Change 1 from NIC's new file 20220301:
The position for SD is longer
----- OK ,no problem from Hasion 3.1

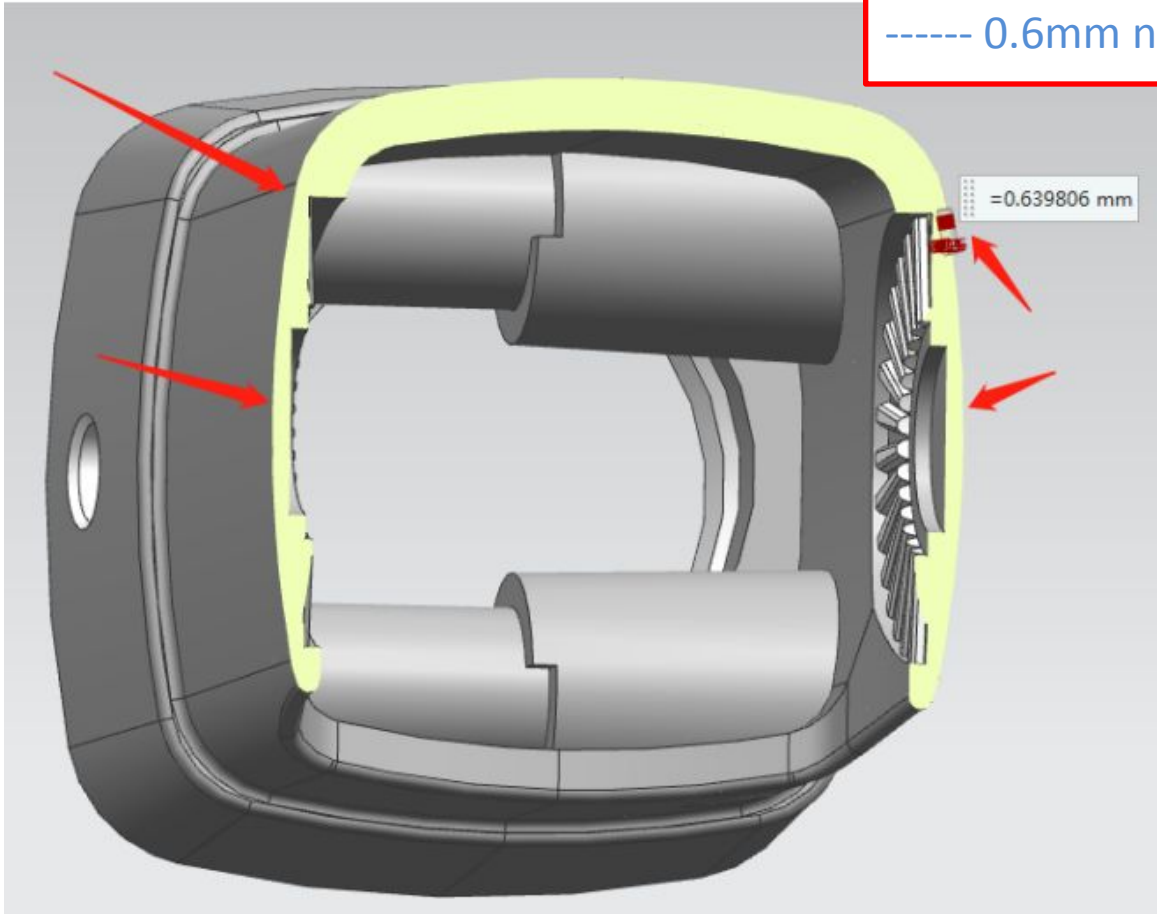
Change 2 from NIC's new file 20220301:
The position for gear
----- OK ,no problem from Hasion 3.1

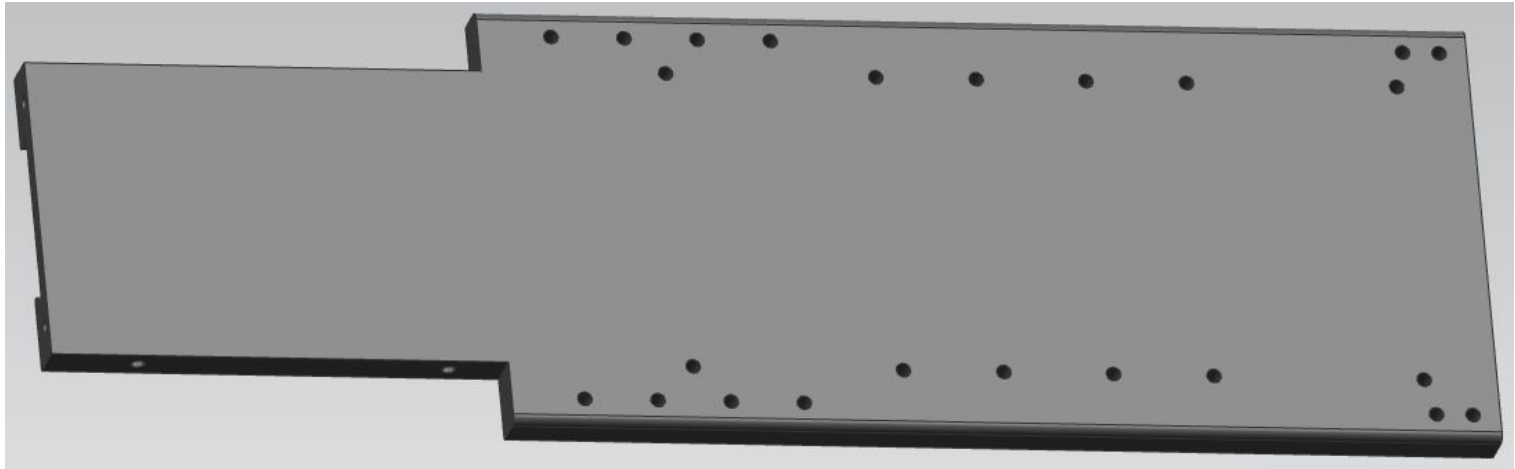
Change 3 from NIC's new file 20220301:

The thickness for here position

----- 0.6mm not OK , It at least 1.2mm--Hasion.3.1

because only 0.6mm thickness ,
too thin , easy to be broken

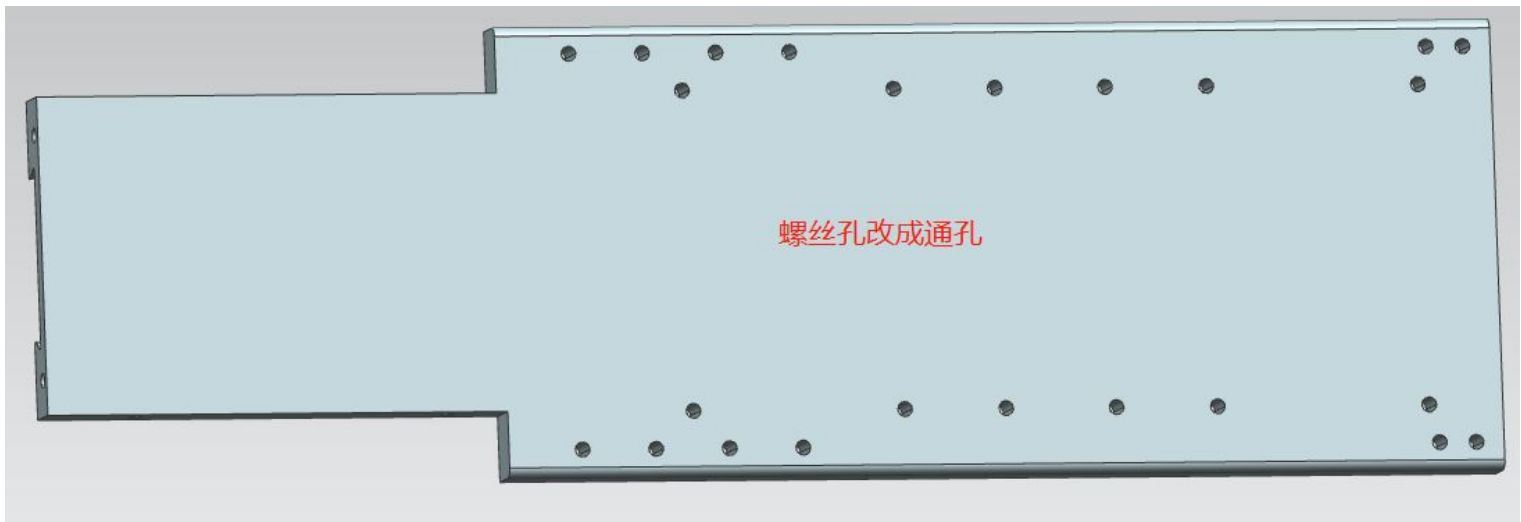
Change 4 from NIC's new file 20220301:
the hole is through hole type

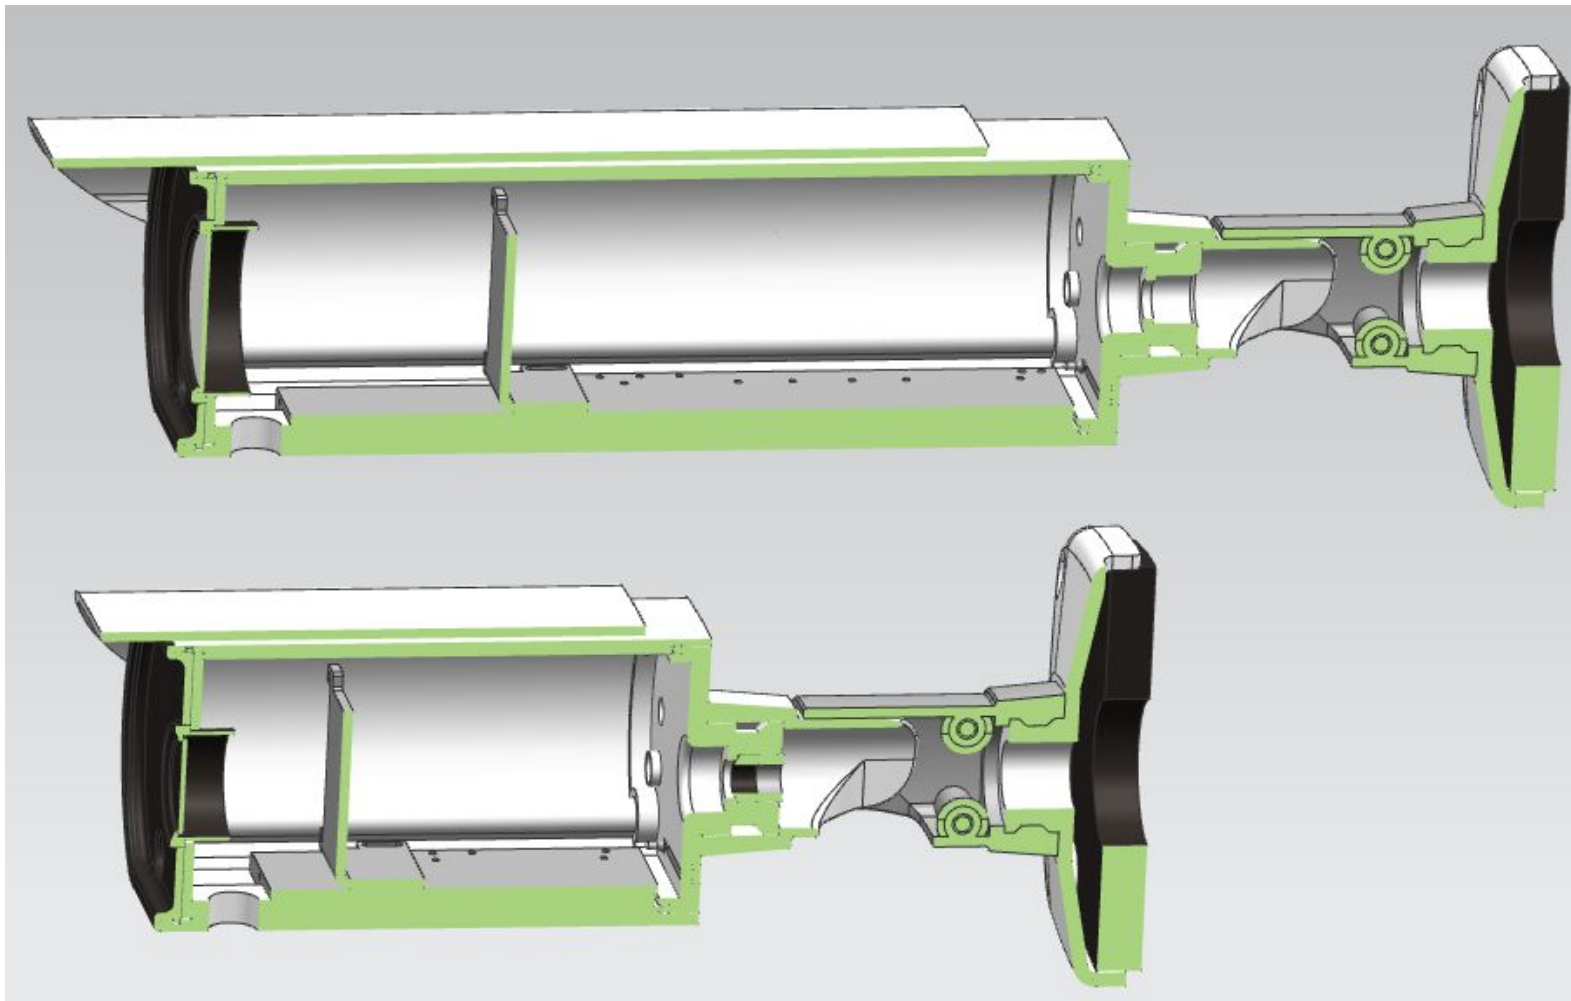
Problem 5 from NIC's new file 20220301:
fixing way of the bracket board

-----the fixing way is not unreasonable, it doesn't improve the fixing --
Hasion 3.1
